AIP Supplement for Singapore

**AIP SUP****073/2021****Effective from 25 MAY 2021****/ 29 NOV 2021****Published on 19 MAY 2021**

SINGAPORE CHANGI AIRPORT – PARTIAL CLOSURE OF TAXILANE R3, TEMPORARY CHANGES TO GROUND MARKINGS AND LIGHTING, AND TEMPORARY DOWNGRADE OF TAXILANE R2 AT TERMINAL 2

ENLARGED LOCATION PLAN SHOWING CLOSED AREA ON TAXILANE R3

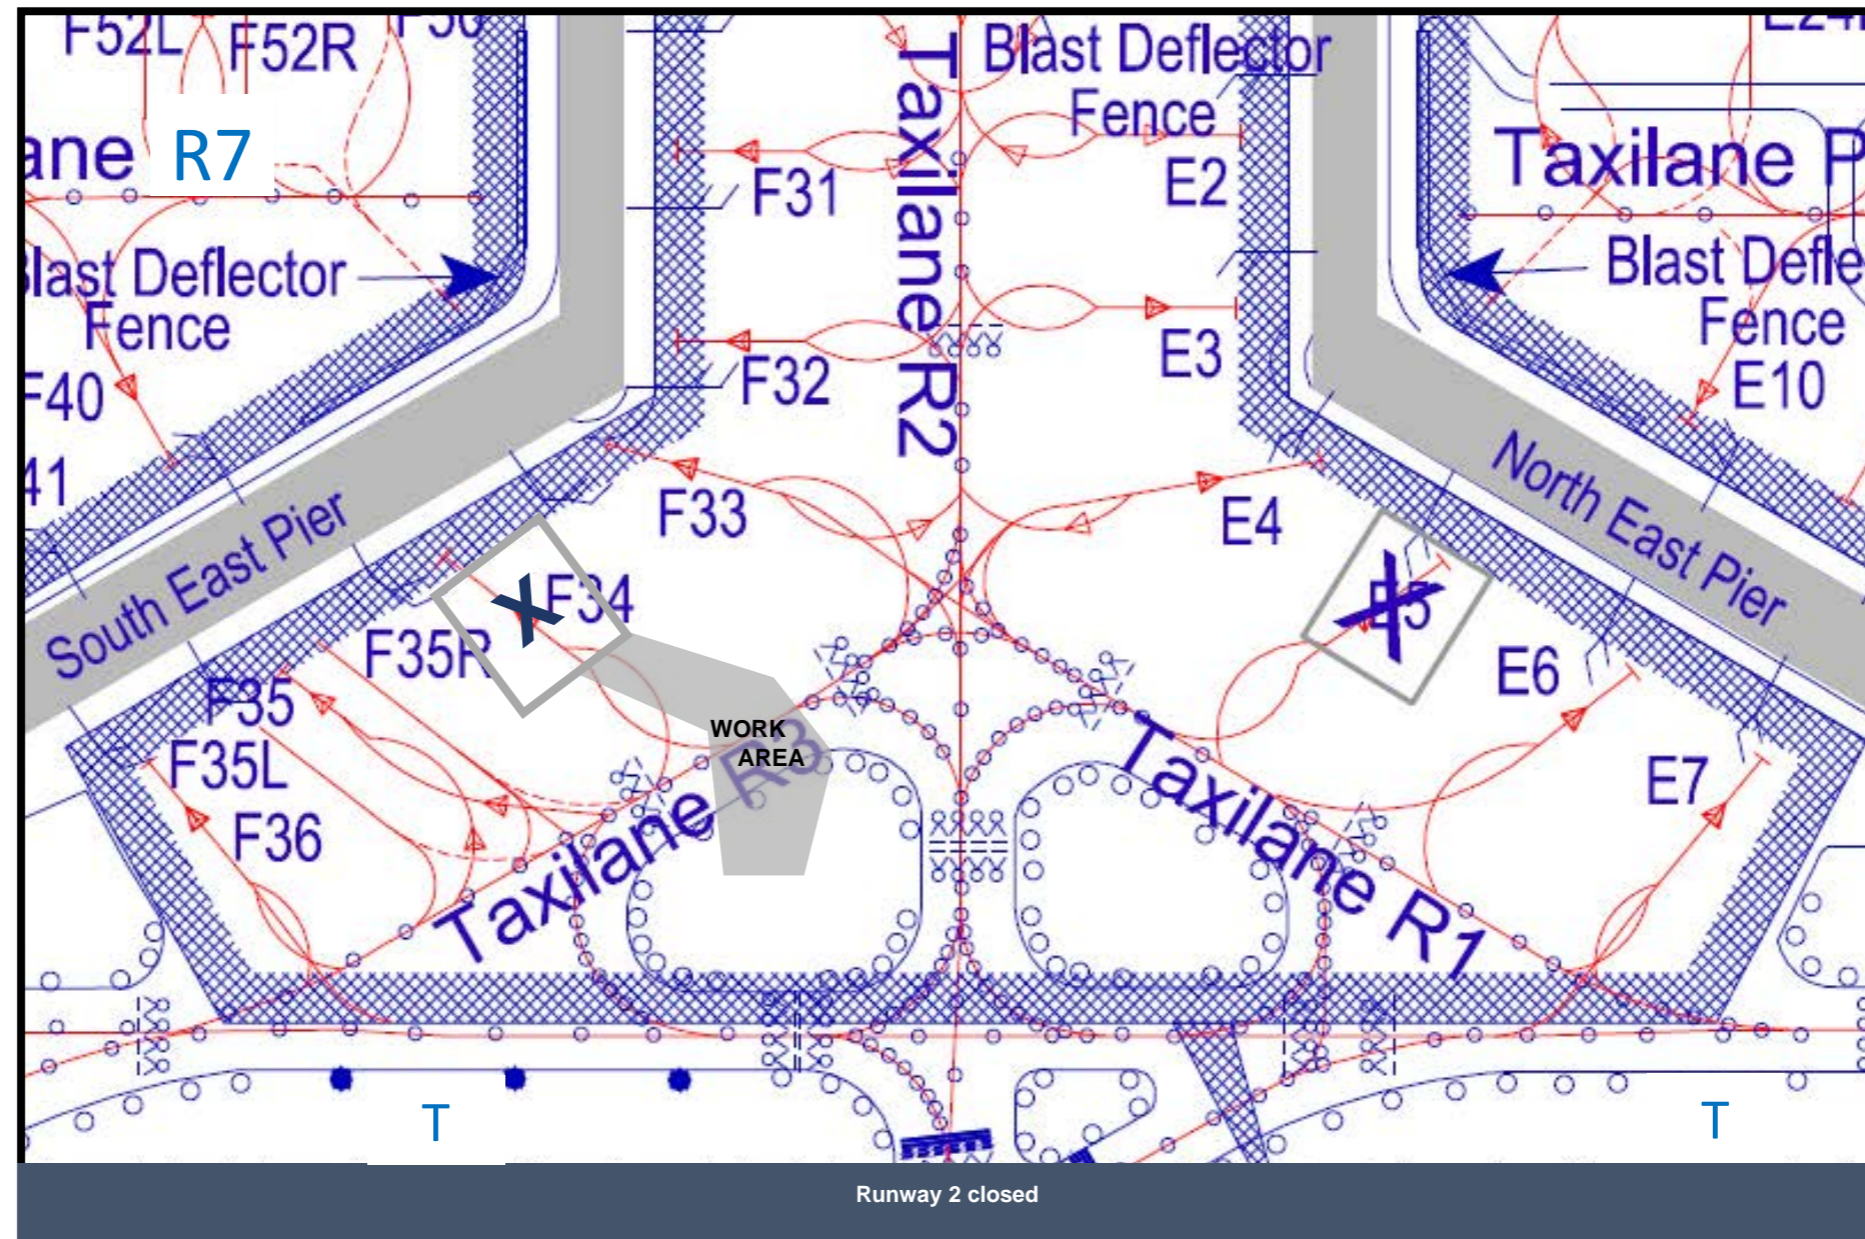
2.1 Taxilane R3 behind aircraft stand F34 will be closed for construction works.

2.2 Enlarged location of work area on taxilane R3 is shown in **Appendix A**.

MAX WINGSPAN 65M MARKINGS ON THE DOWNGRADED SEGMENT OF TAXILANE R2

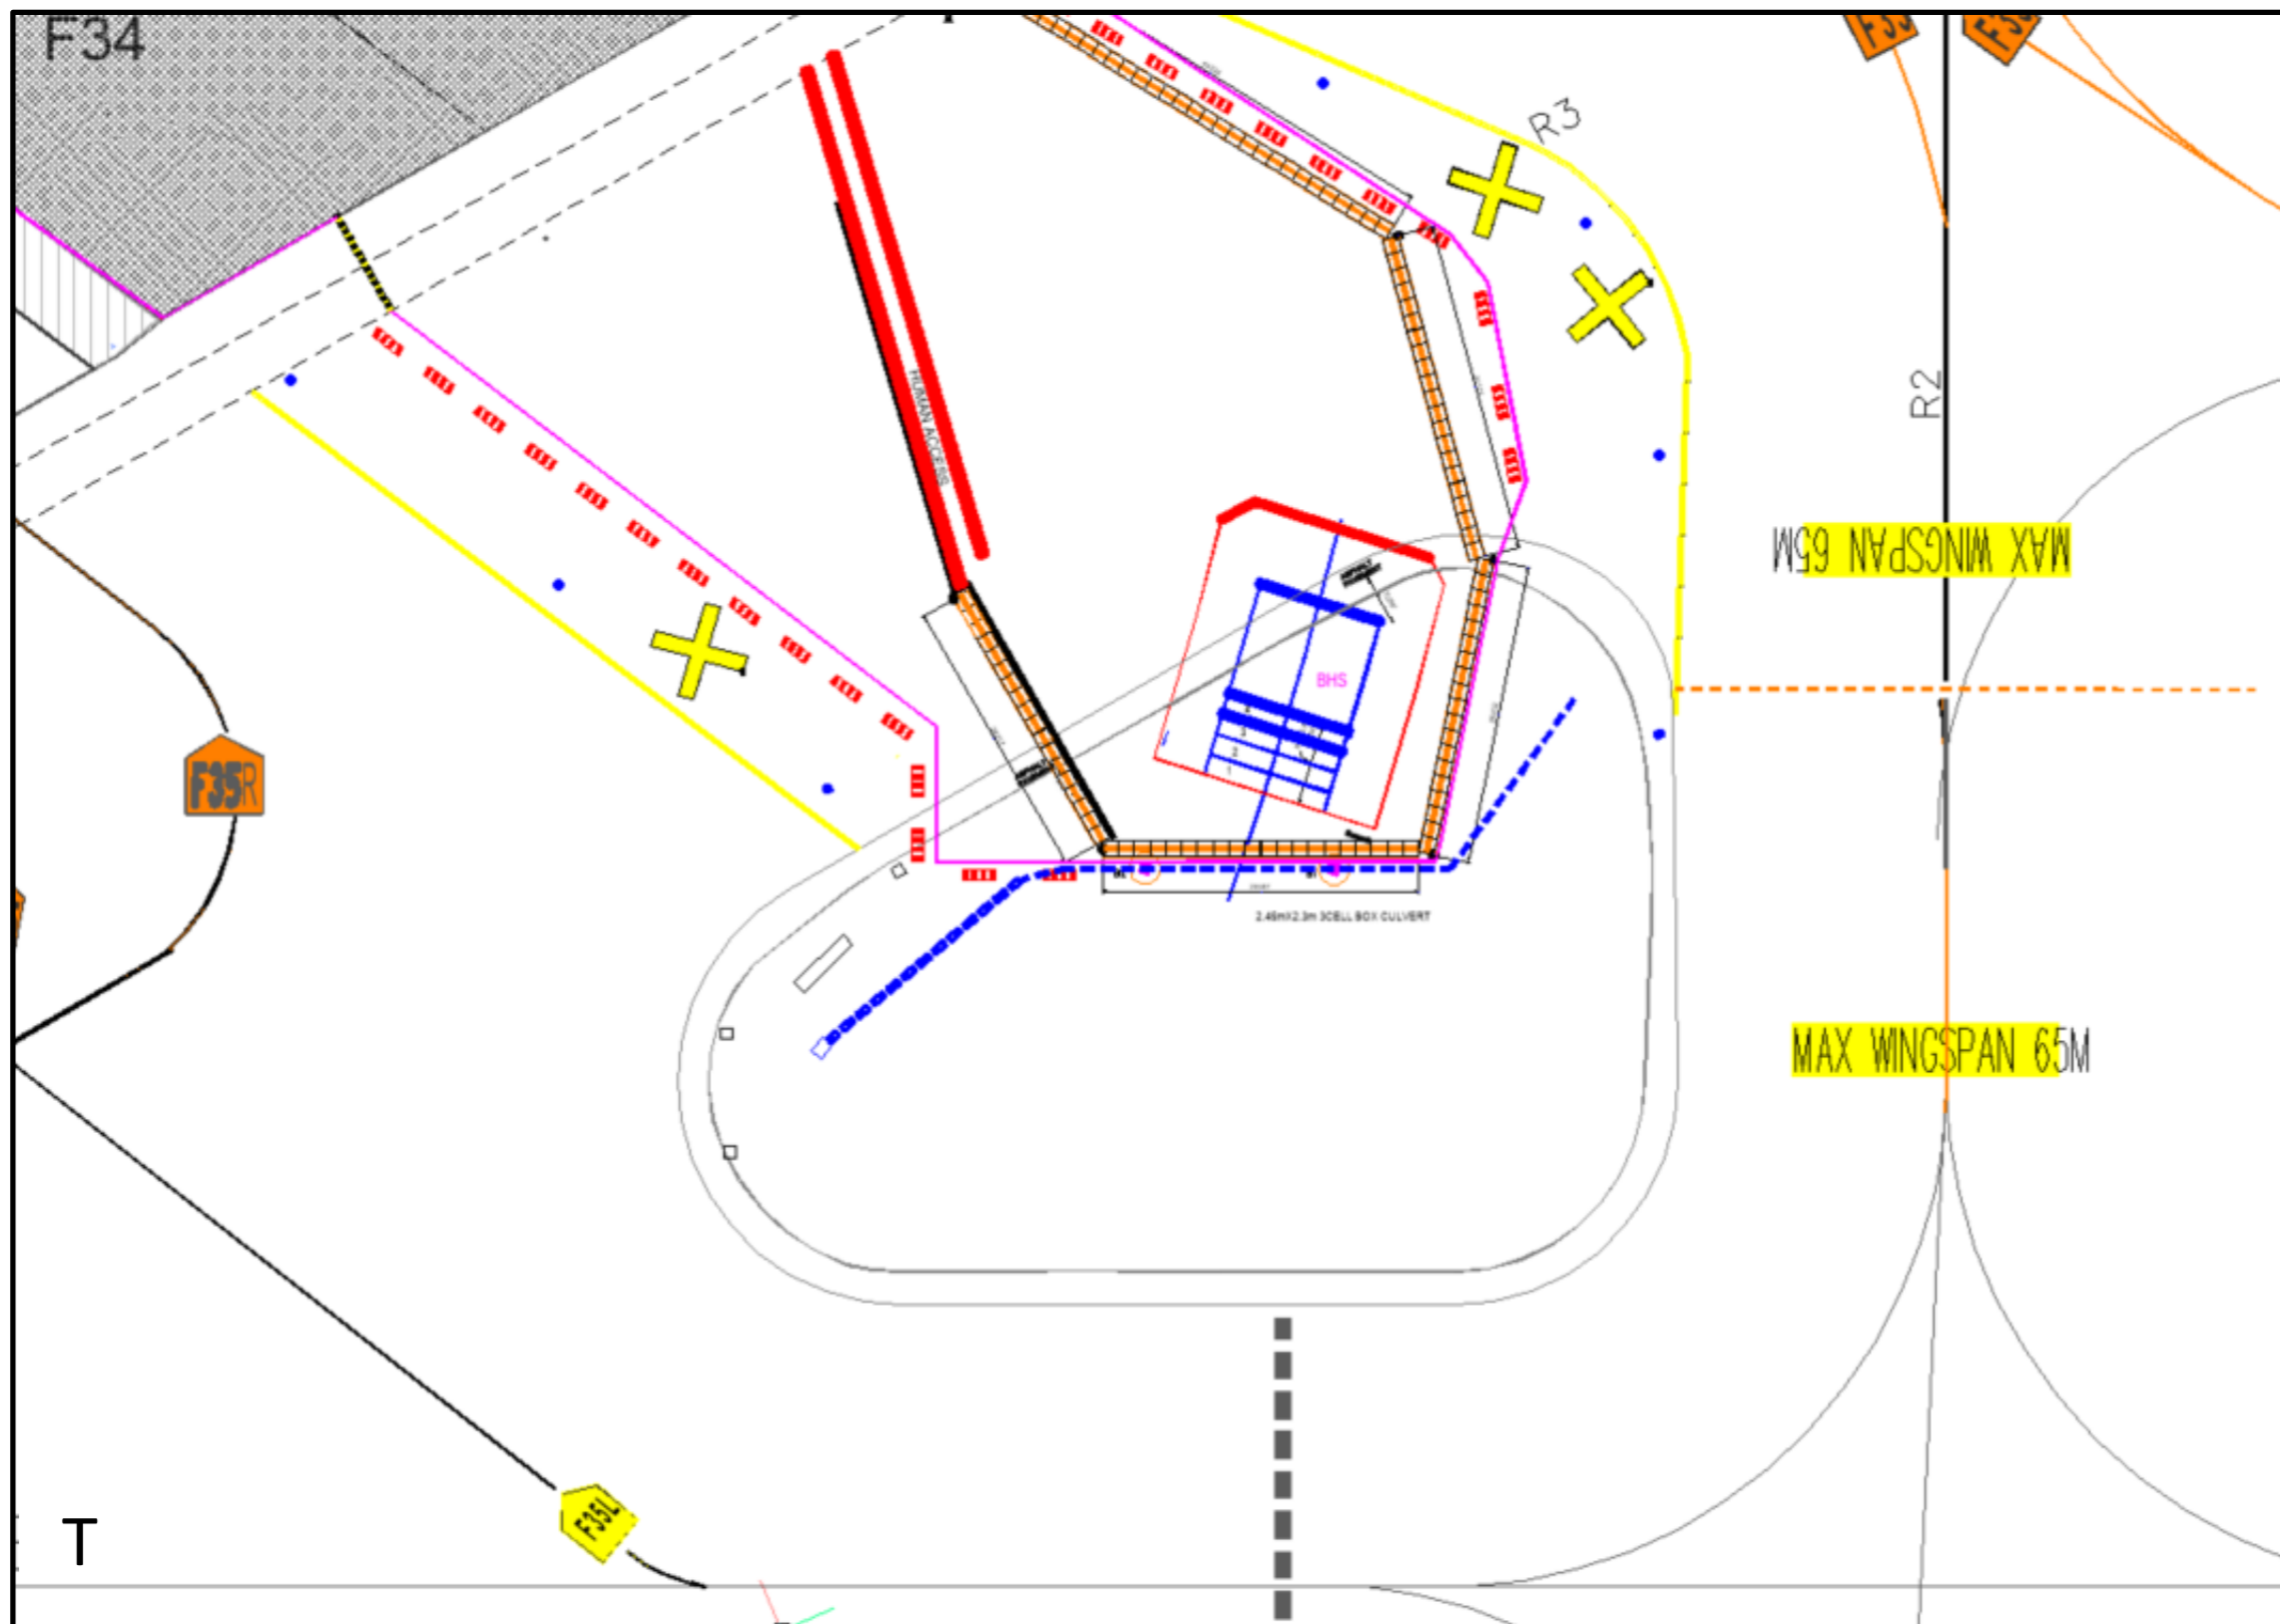
3.1 Taxilane R2 between junction of taxilane R1/R2/R3 and taxiway T will be downgraded from Code F to Code E.

3.2 Two “MAX WINGSPAN 65M” markings will be painted at the junction of taxilane R1/R2/R3 and junction of taxilane R2/taxiway T to provide a visual cue of the downgraded segment of taxilane R2. The location of the markings is shown in **Appendix B**.

**TEMPORARY CHANGES TO GROUND MARKINGS AND LIGHTING WITH EFFECT
FROM 25 MAY 2021 0100UTC TO 29 NOV 2021 2200UTC**

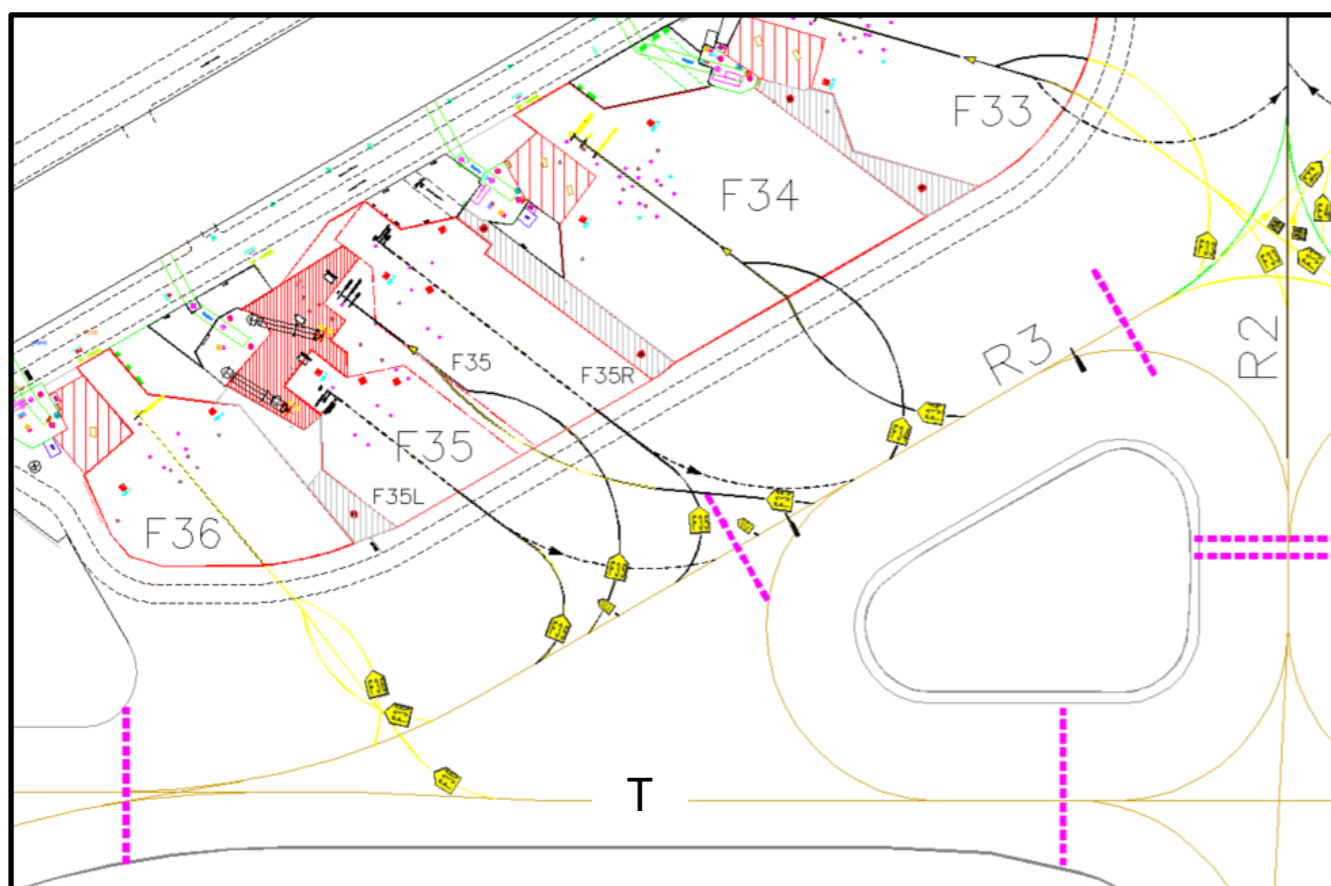
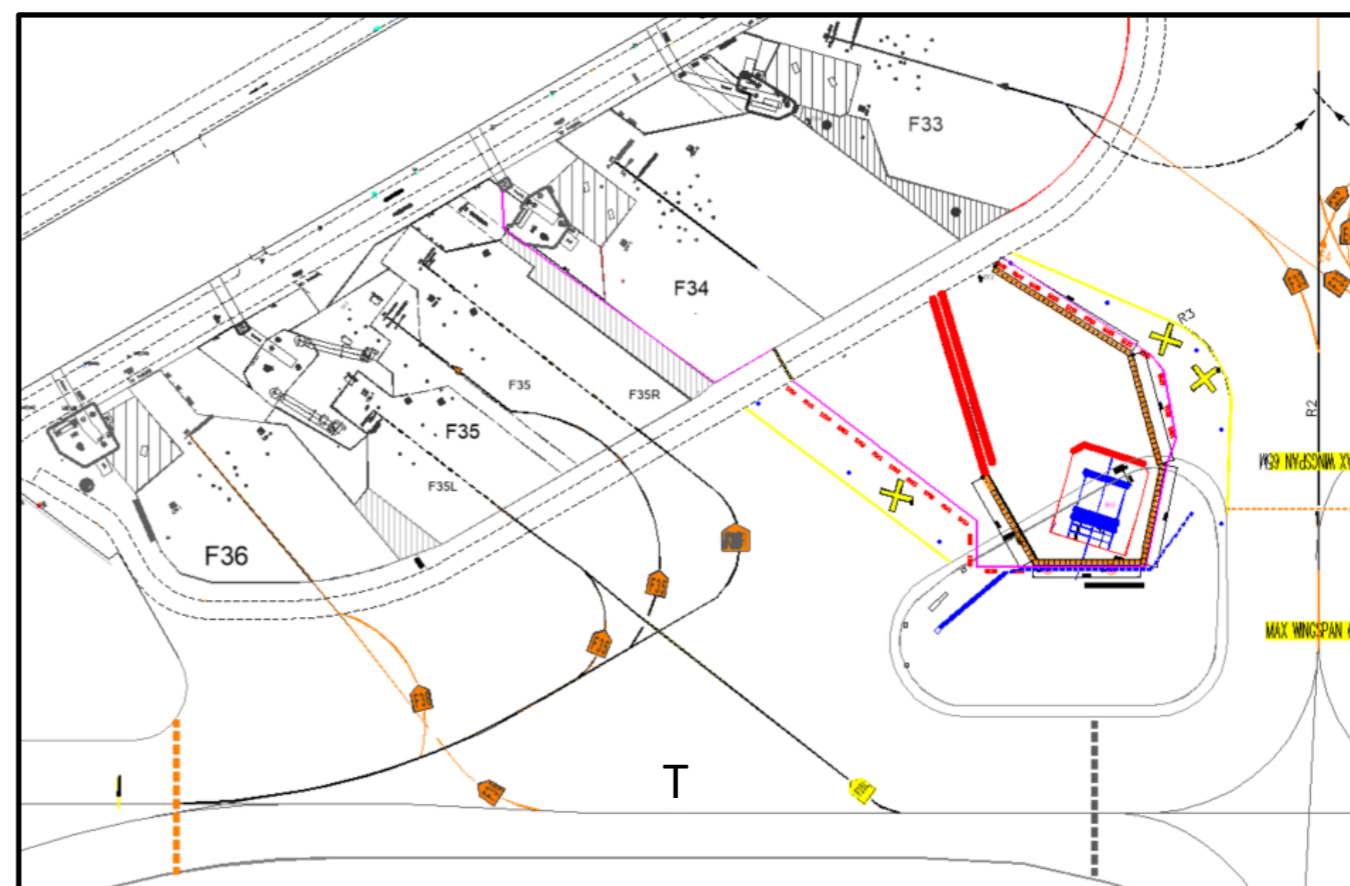
4.1 Due to the partial closure of taxilane R3, ground markings and airfield lighting will be revised/removed as follows:

- a. Aircraft stand lead-in line will be provided from taxiway T (towards South) directly into aircraft stand F35L;
- b. The existing “EOT F34, F35L, F36” on taxilane R3 will be removed and replaced with an “EOP F35, F35R, F35L, F36” on taxiway T;
- c. Taxiway centreline and lights on taxiway T (towards South), turning West into taxilane R3 will not be available.

4.2 A schematic showing the existing markings and the revised markings are as shown in **Appendix C**.
